# Access Compliance Report

### (Curb Ramps)

Intersection ID: 30545	Main Street: COLONY_RD	Cross Street: STONECROFT_PARK_DR	Location: W
ADA ID: 6CF37D25D302	Ramp Type: PerpDiag	Initial Pass/Fail: Fail	Overall Compliance: No
Severity Score: 10			
Codes/Mitigation Info/Possible Solution		Field Measurements/Component Compliance

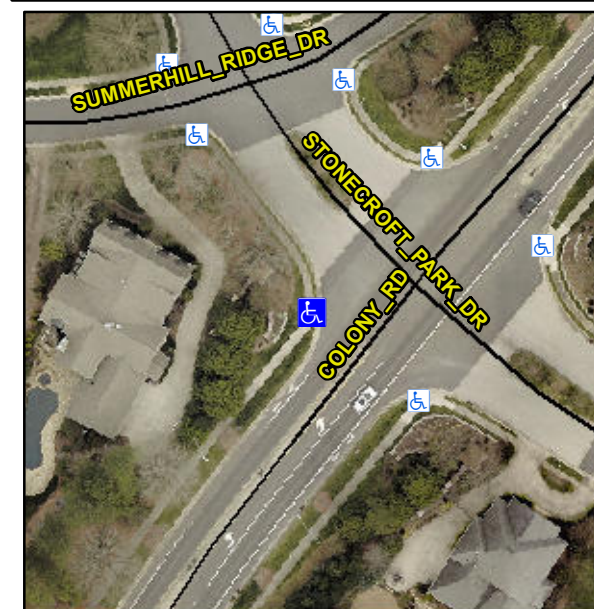
**Not Found, R304.5.1, R304.5.3**

Compliance	Description	Data	Compliance	Description	Data
N/A	Ramp Length (in)	70.0	Yes	Ramp Slope (%)	5.3
No	Ramp Width (in)	43.0	No	Ramp XSlope (%)	2.9
N/A	Flare Type LT	N/A	N/A	Flare Type RT	N/A
N/A	Flare Slope LT (%)	N/A	N/A	Flare Slope RT (%)	N/A
N/A	Flare Traversable LT?	N/A	N/A	Flare Traversable RT?	N/A
N/A	Landing Length (in)	N/A	N/A	DWS Provided?	N/A
N/A	Landing Width (in)	N/A	N/A	DWS Contrast?	N/A
N/A	Landing Slope (%)	N/A	N/A	DWS Length (in)	N/A
N/A	Landing X Slope (%)	N/A	N/A	DWS Full Width?	N/A
N/A	Landing Curb? (Y/N)	N/A	N/A	DWS Offset (in)	N/A
N/A	Shared Landing?	N/A			
N/A	Gutter Ponding?	N/A	N/A	Gutter Slope (%)	N/A
N/A	Gutter Lip Ht (in)	N/A	N/A	Gutter X Slope (%)	N/A
N/A	Painted X Walk1?	No	N/A	Painted X Walk2?	No
	X Walk 1 Direction	To SE		X Walk 2 Direction	To NE
N/A	X Walk 1 Width (in)	N/A	N/A	X Walk 2 Width (in)	N/A
	X Walk 1 Slope (%)	4.6		X Walk 2 Slope (%)	1.0
	X Walk 1 X Slope (%)	0.6		X Walk 2 X Slope (%)	4.7

**Remove & Replace Curb Ramp With Two New Directional Ramps or Equivalent.**
